Seabrook Station

Seabrook Station, License Renewal Application Relating to the  
Alkali-Silica Reaction (ASR) Monitoring Program

**Seabrook Station License Renewal Application  
Relating to the Alkali-Silica Reaction (ASR) Monitoring Program  
for the Seabrook Station License Renewal Application  
Clarifying Information and Response to Requests for Additional Information**

Aging Management Program B.2.1.31.B-*Building Deformation* Element 3-*Parameters Monitored/Inspected* Stage 1: Susceptibility Screening Evaluation (SBK-L-16013 / Enclosure 4 / Page 25) is revised to reflect that a Stage 1 evaluation may progress directly to a Stage 3 Detail Evaluation

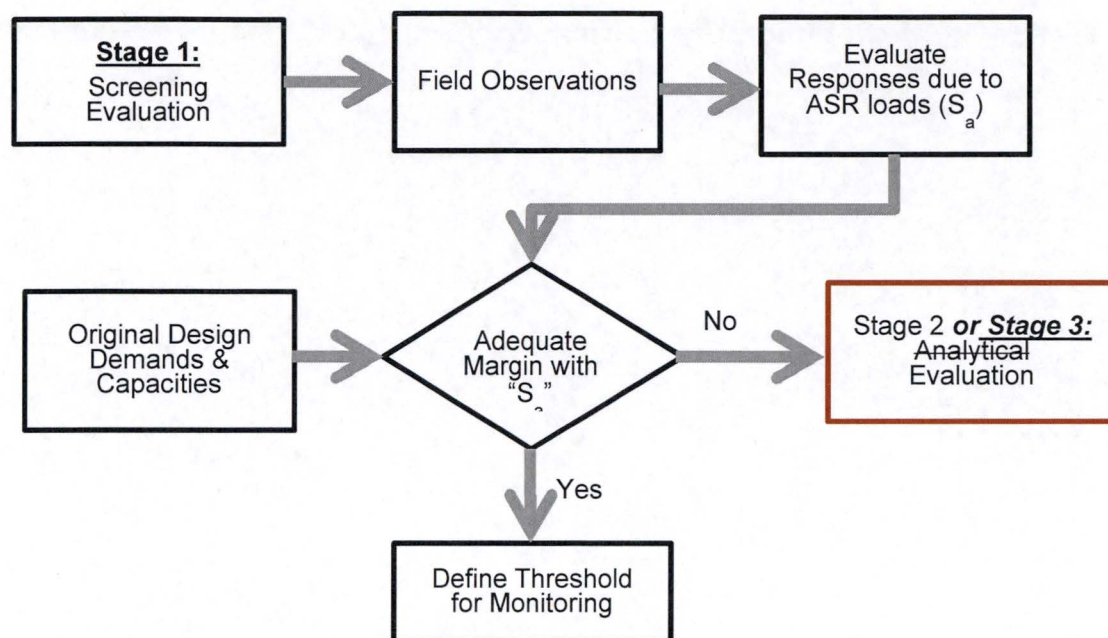
1. NextEra Energy Seabrook stated it needed to clarify that for the Building Deformation program, it does not need to start with a "stage 1" evaluation and that the evaluation for each structure can start at any of the three stages (using a general basis), and if necessary progress to higher stages where necessary. NextEra Energy Seabrook stated it will modify the submittal anywhere (i.e., instances in the submittal) that reads as though a structure must be analyzed at a lower stage before conducting an analysis at a higher stage.

Aging Management Program B.2.1.31.B-*Building Deformation* Element 3-*Parameters Monitored/Inspected* (SBK-L-16013 / Enclosure 4 / Page 22) is revised to include statement regarding the initial selected analysis stage:

A three ~~step~~-*stage* process will be used to initially screen for deformation and to analyze the effects on structures for the self-straining loads from ASR expansion, creep, shrinkage, and swelling. Each stage of the process would have increasing levels of rigor. *The analysis and evaluation of each structure may begin at any of the three stages. If initial review of a structure determines that a structure cannot be qualified in a particular evaluation stage due to high ASR expansion, low margin in the structural design, or any other limitation that excludes the structure from being qualified at that stage, the structure can be evaluated at a higher stage evaluation that employs more rigor. Ultimately the structure is classified according to the stage in which it is qualified to meet the design code requirements and monitored accordingly. For example, a stage 2 structure is qualified using a stage 2 evaluation and thresholds are monitored to stage 2 thresholds.*
